To: Selwyn District Council
From: Hugh Nicholson, Urban Designer
Date: 30 November 2022
Re: DPR-0436 Dunsandel Rezoning Request for Proposed Selwyn District Plan
Urban Design and Landscape Review

Figure 2: Preferred future development areas from *Ellesmere Plan 2031*

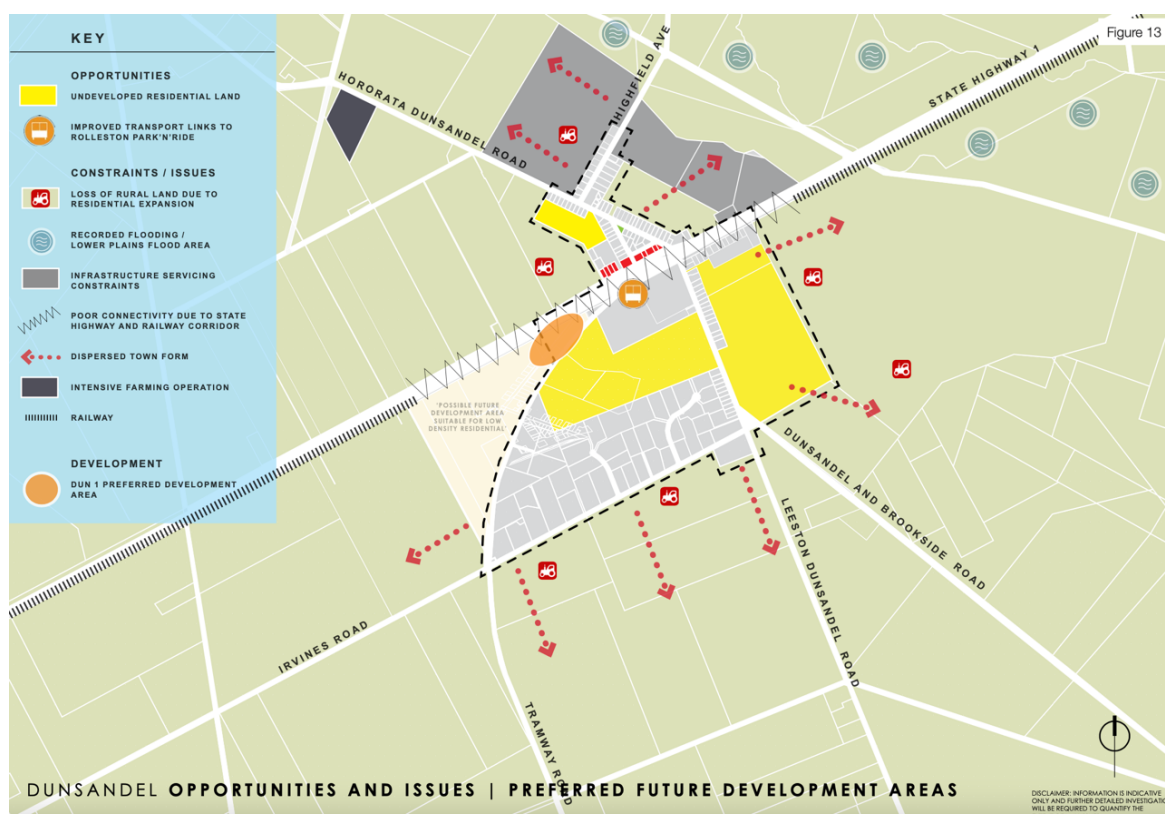
- 4.3 In my opinion the proposed rezoning of this site would not contribute to a consolidated or compact urban form for Dunsandel. There are three areas of

undeveloped rural land identified in the *Ellesmere Plan 2031* which are closer to the township which would contribute to a consolidated and compact urban form if they were developed. I consider that these alternative blocks of land present better options for accommodating residential growth in Dunsandel.
